FARRAGUT MUNICIPAL PLANNING COMMISSION AGENDA

**May 20, 2021 – 7:00 p.m.
Town of Farragut Community Center**

- 1. Approval of agenda**
- 2. Approval of minutes – April 15, 2021**
- 3. Discussion and public hearing on a preliminary plat for the Grove at Boyd Station Subdivision, Parcels 50, 50.01, 9.01, and 54.01, Tax Map 162, 12611 Boyd Station Road, 132 Acres, 285 Lots, Zoned R-1/OSMR (Rackley Engineering, Applicant)**

REPORT TO THE FARRAGUT MUNICIPAL PLANNING COMMISSION

Sheet
C101
 SHEET 8 OF 24

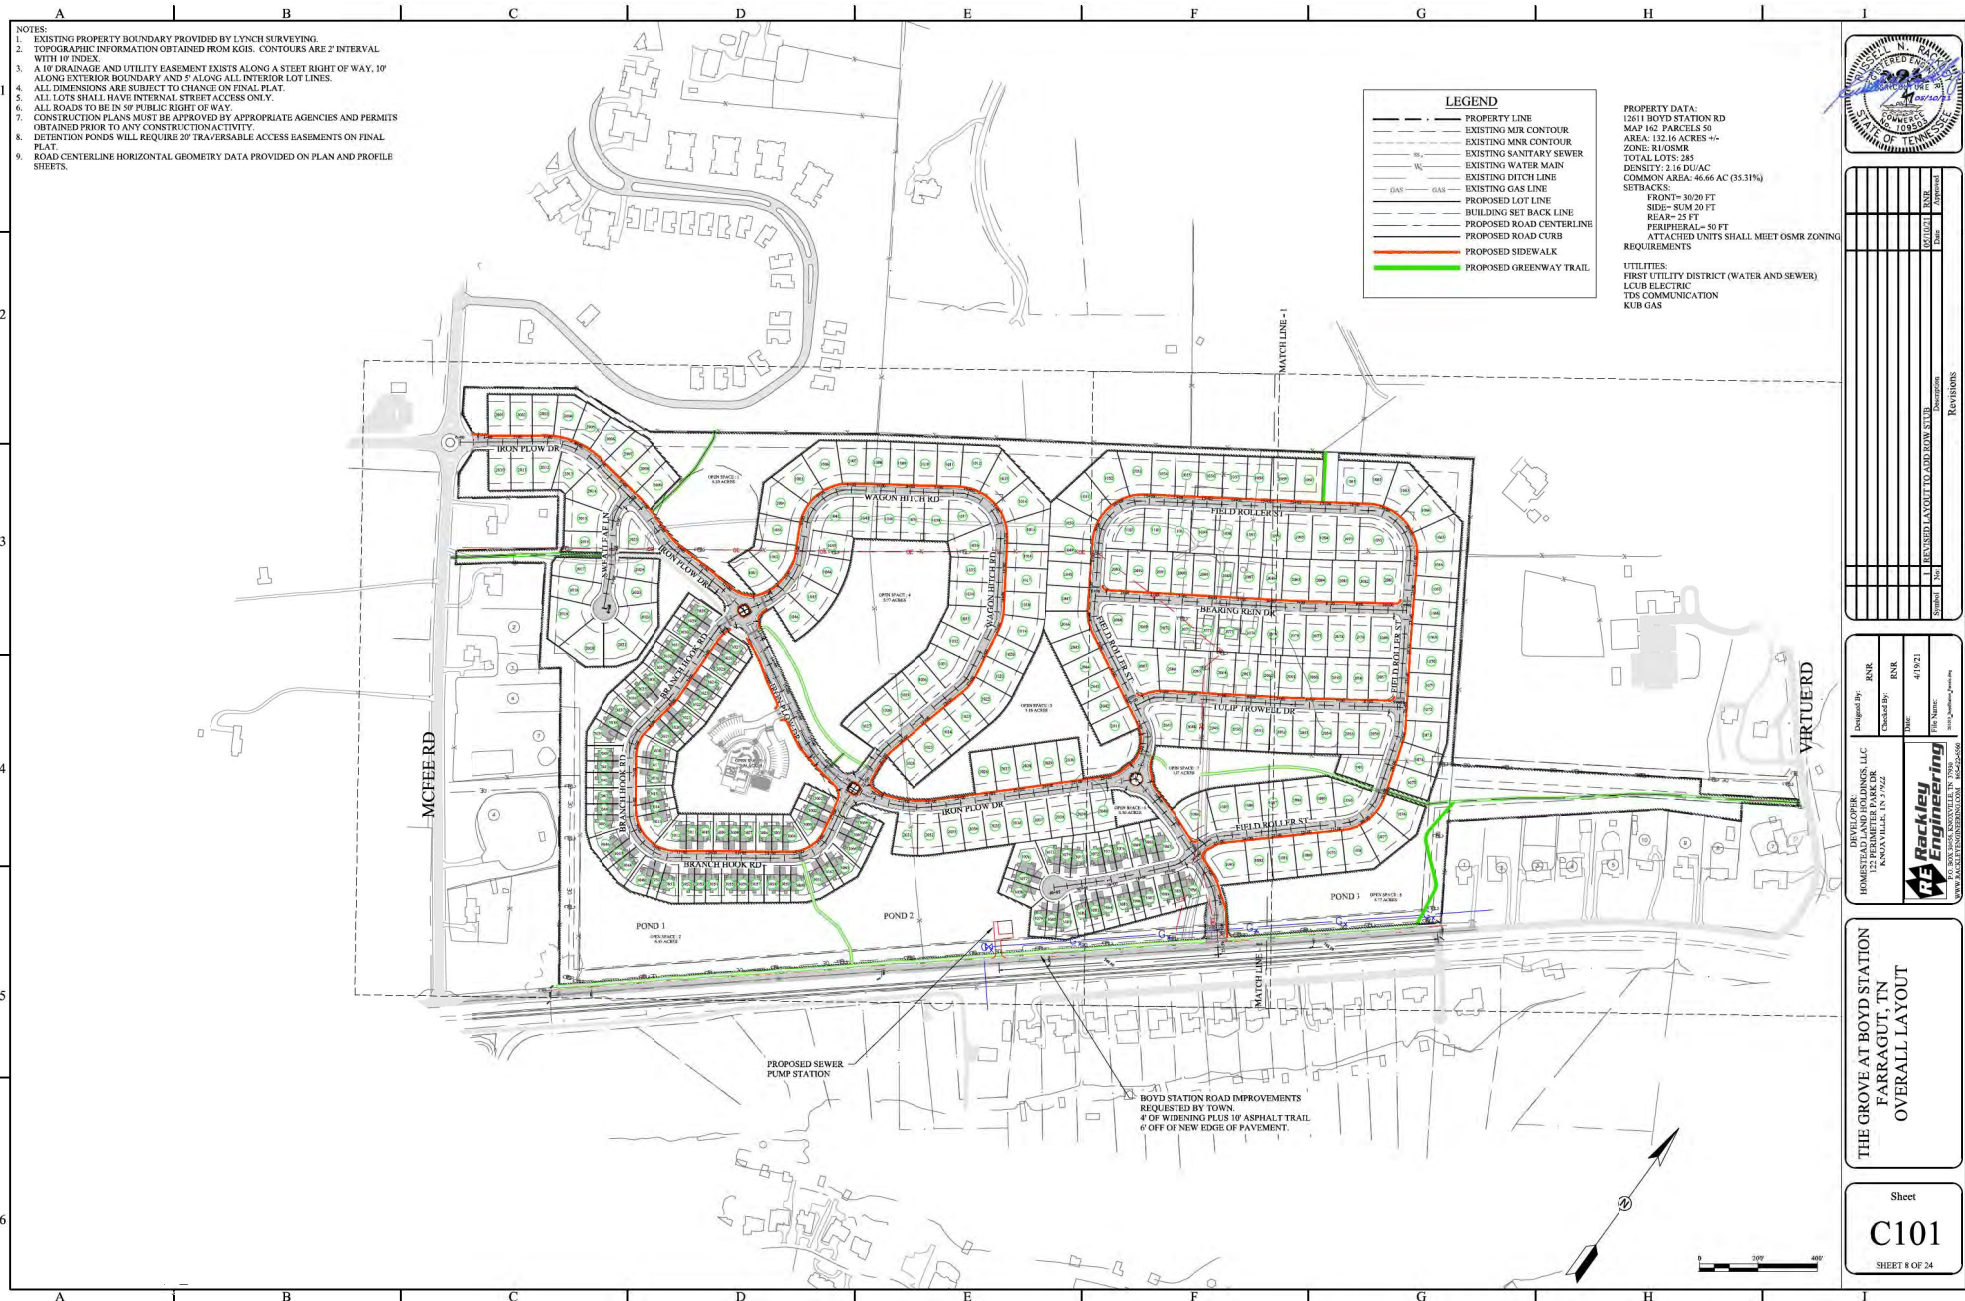
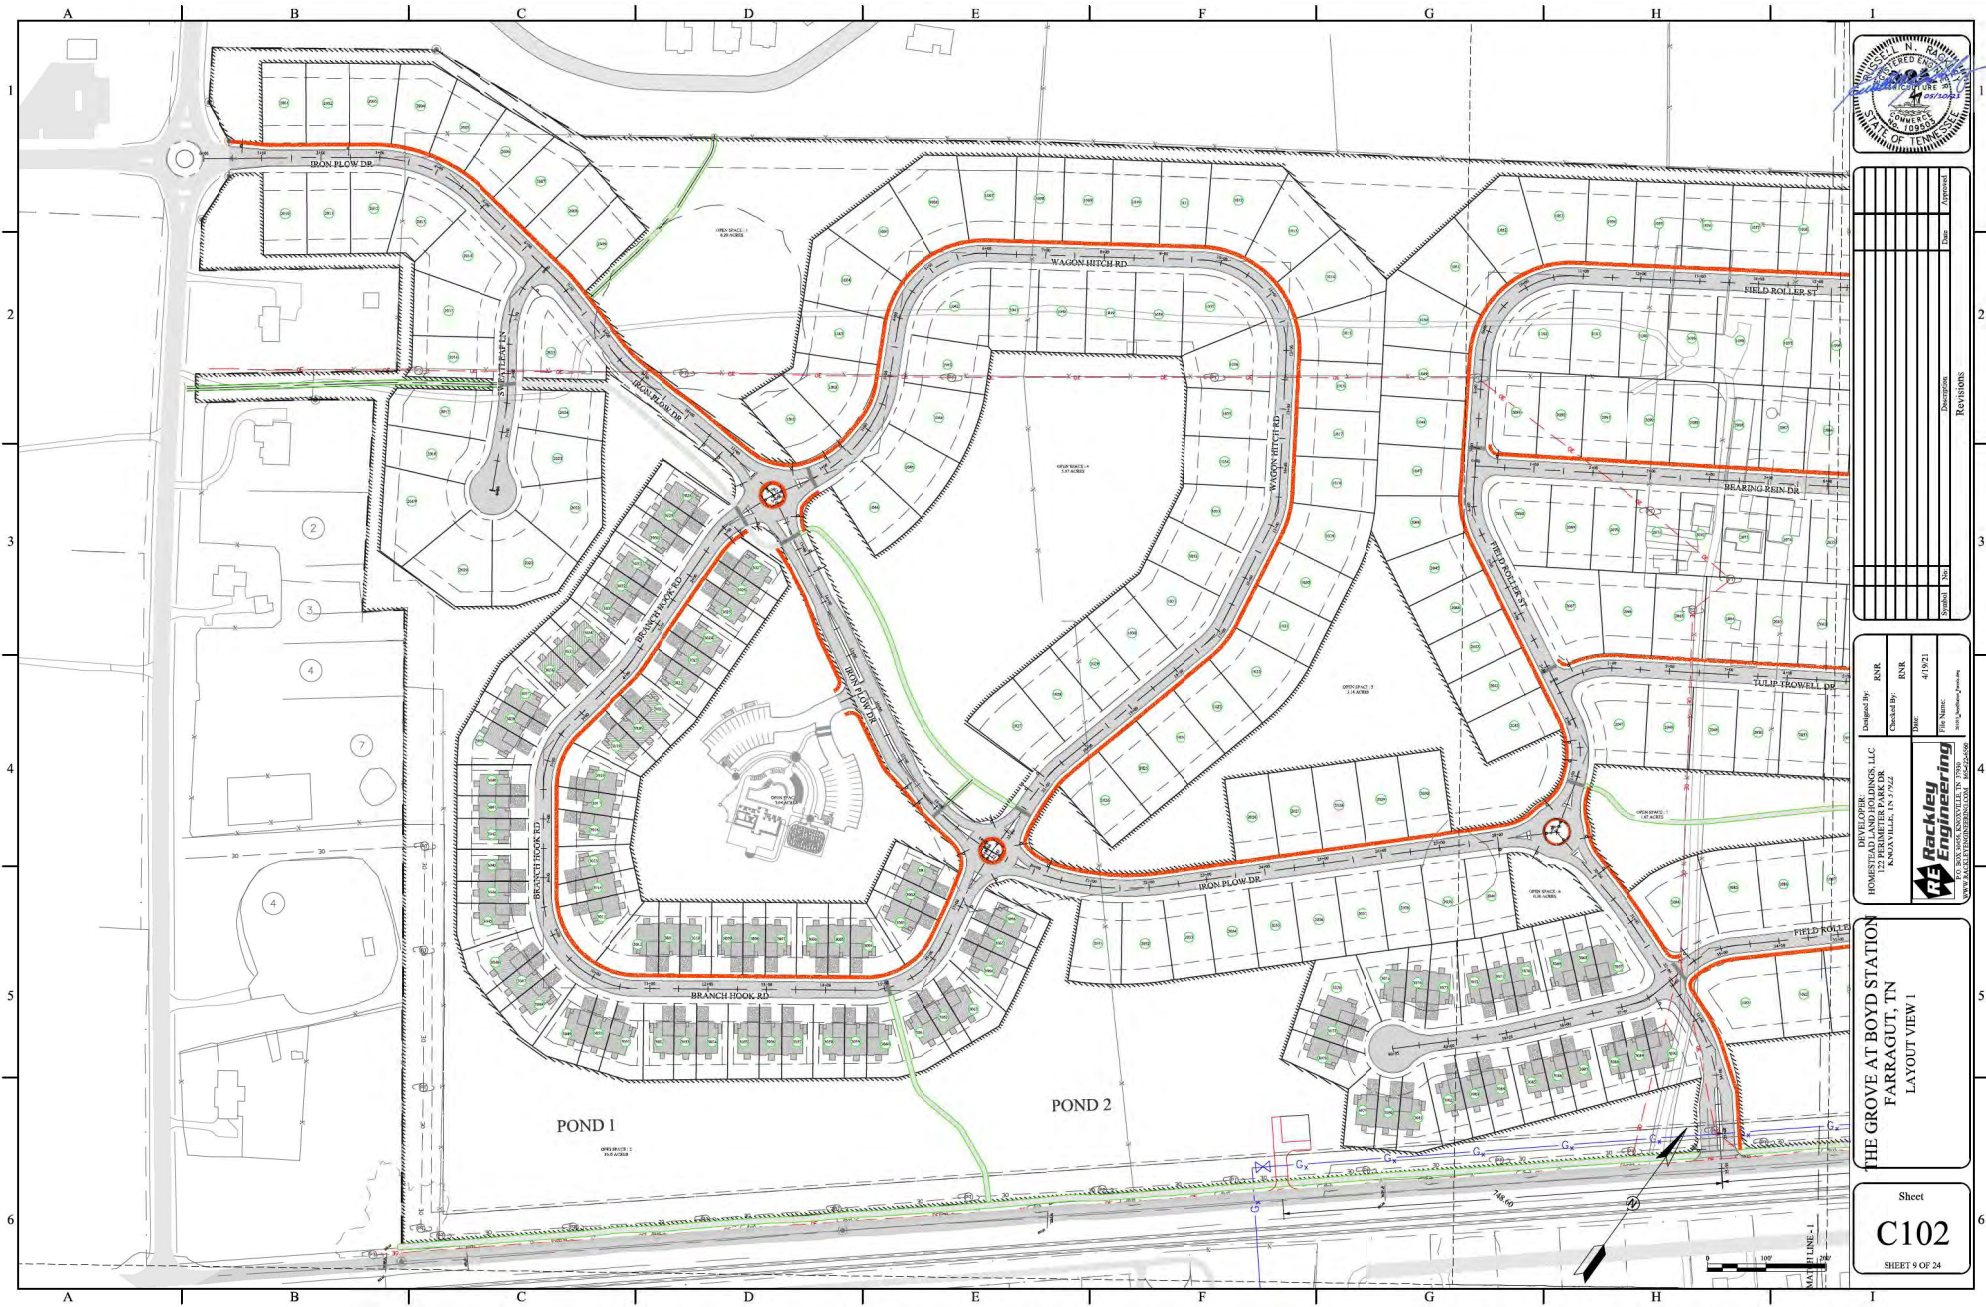
- 9) Since Hay Fork Lane does not have a sidewalk, please connect the end of Hay Fork Lane to the walking trail along Boyd Station Road.
- 10) On Sheet C101, please note in the setback summary that the detached buildings must be at least 20 feet apart for side setback purposes. The preliminary plat will need to address the front face offsets required for the attached units per the OSMR.

THE GROVE AT BOYD STATION
 FARRAGUT, TN
 IRON PLOW DR PROFILE

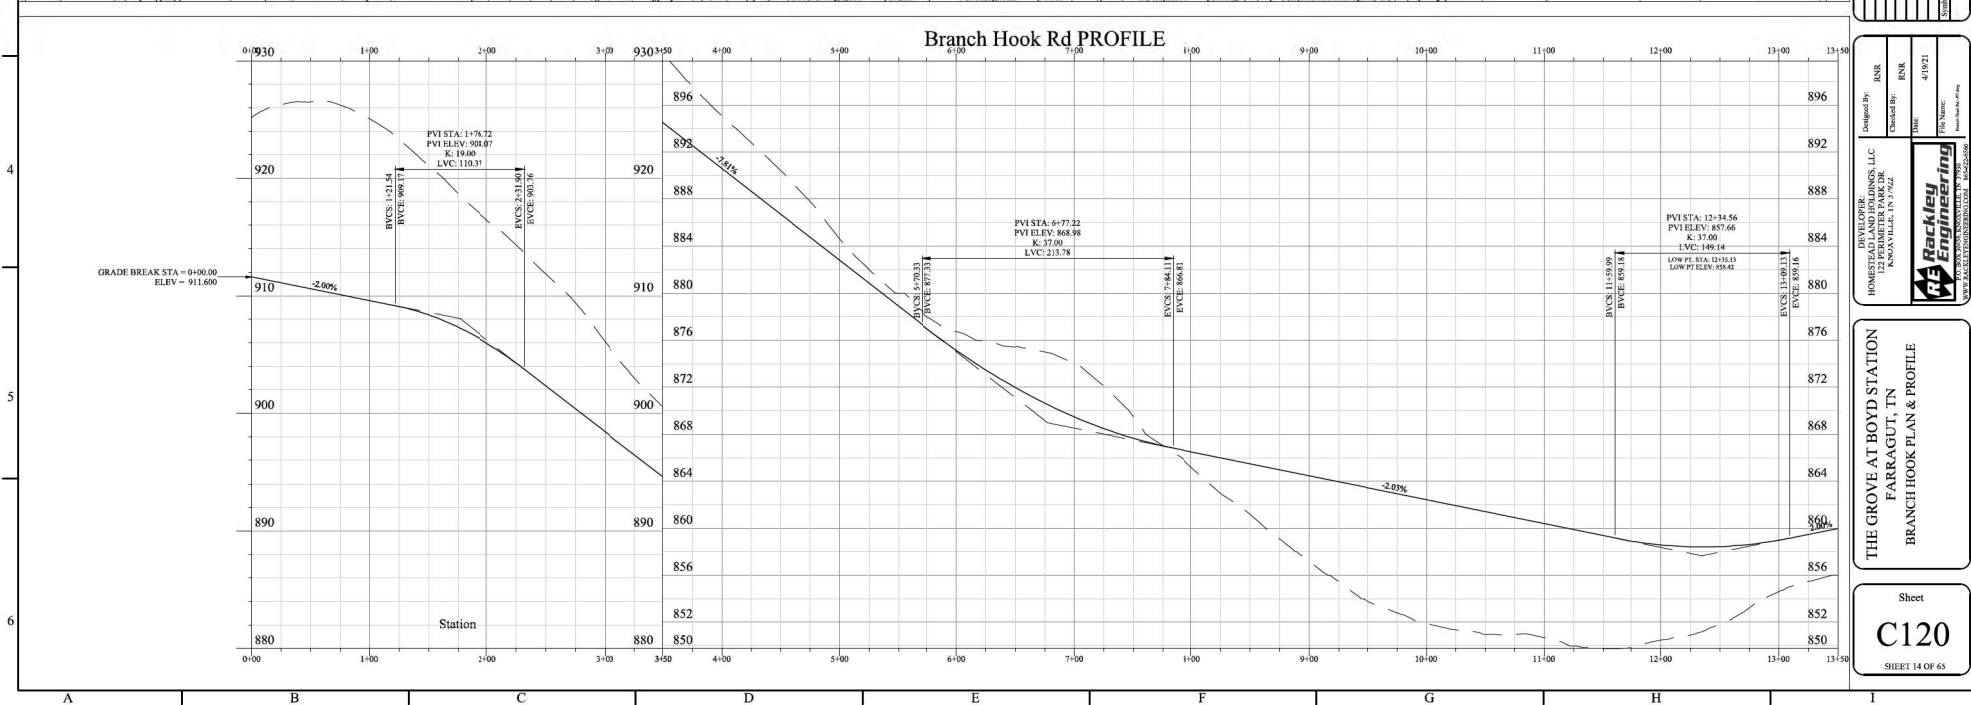
- 1) A question for the Commission is whether, given its length and potential amount of traffic, a sidewalk should be provided on both sides of Iron Plow Drive. Per the Subdivision Regulations, the Commission has the authority to require a pedestrian facility on at least one side of a spine street. In consideration of this the Commission should evaluate the anticipated use of such facilities, the frequency of pedestrian/vehicular conflicts, and whether such additional facilities would significantly contribute to the Town's existing or projected pedestrian network. The Commission should also consider the additional public maintenance costs associated with any additional sidewalks and/pedestrian facilities.

THE GROVE AT BOYD STATION
FARGAGO, TN
SEWER OVERALL LAYOUT

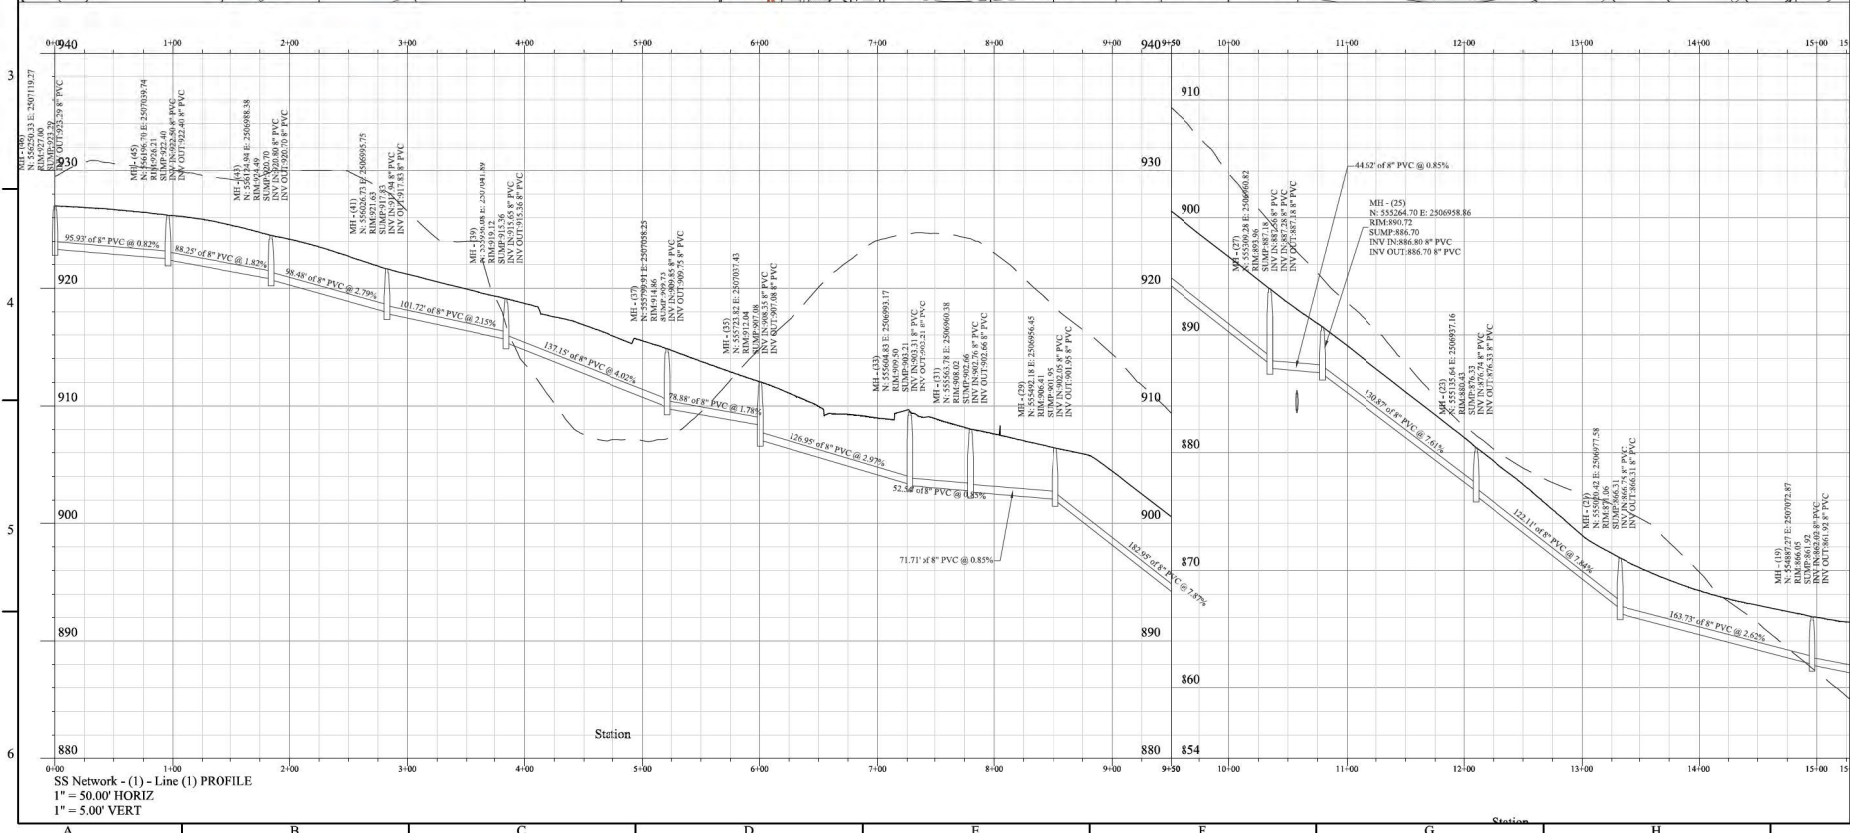
Does the force-main extend across the back of this lot (see note on sheet 49)? If so, will a wider easement be required?

See response above.
